FINAL BUILDING CODE OF AUSTRALIA 2022 REPORT

PROPOSED SENIORS LIVING DEVELOPMENT

7-9 Brighton Road, 21 Charles Street Peakhurst NSW 2210

Report Ref: BCA Final Report 22-219462 R03.docx

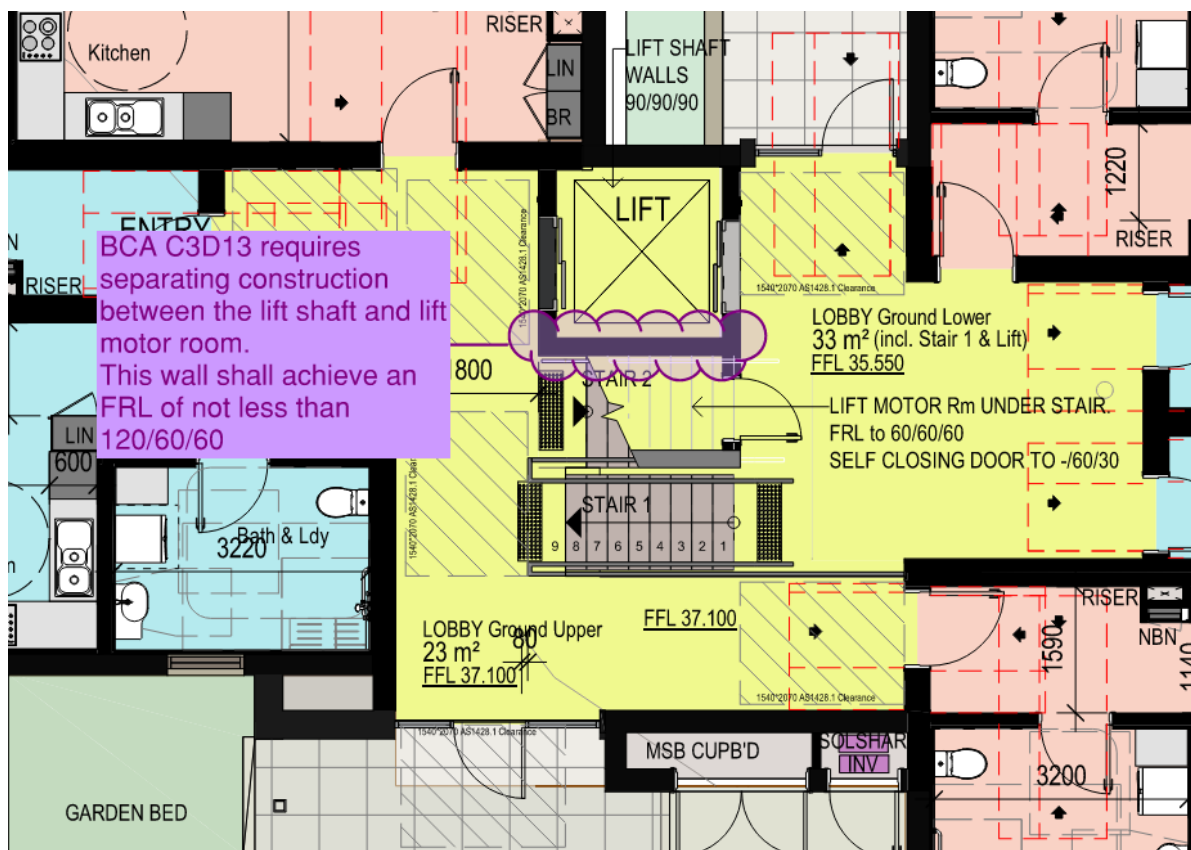
10. **Fire Compartmentation (C3D3)** – The fire compartmentation of the Class 2 (Residential) building components are based on a floor-by-floor separation which is deemed compliant as no floor area limitations under Table C3D3 are applicable to Class 2 building parts.

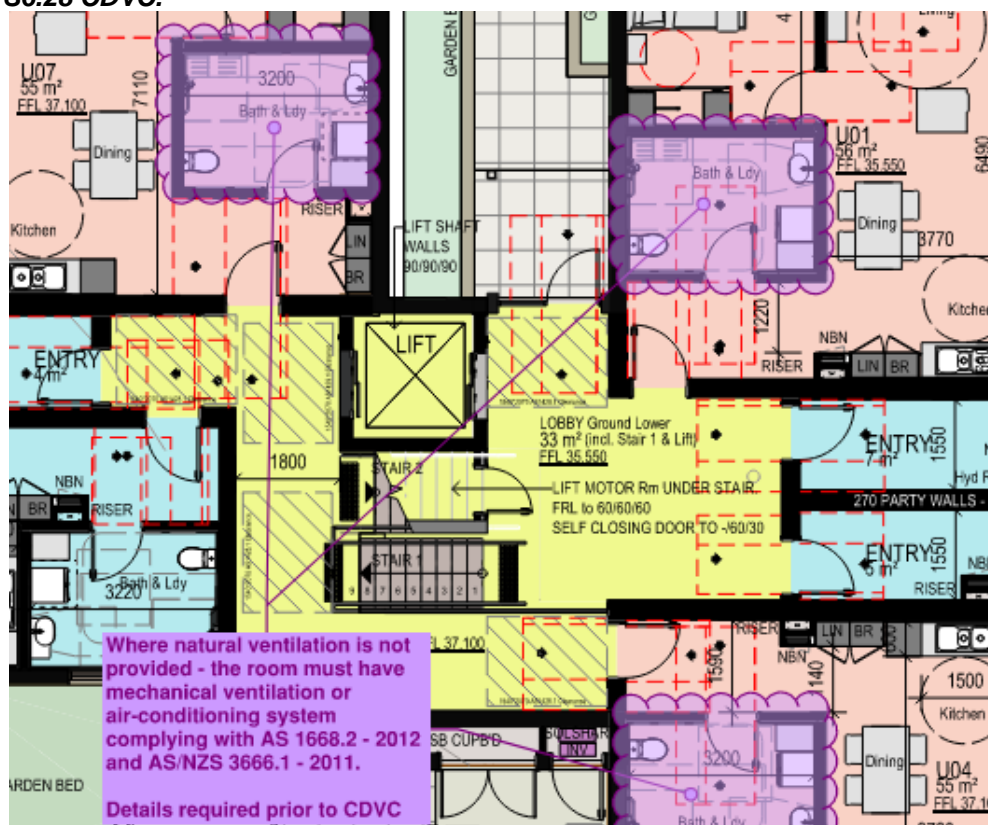
22. **Exit and emergency lighting** – Emergency lighting must be installed in every passageway corridor, hallway or the like having a length of more than 6m from the entrance doorway of any sole-occupancy unit to the doorway opening directly to a road or open space. **Electrical consultant to provide details prior to issue of the S6.28 CDVC.**
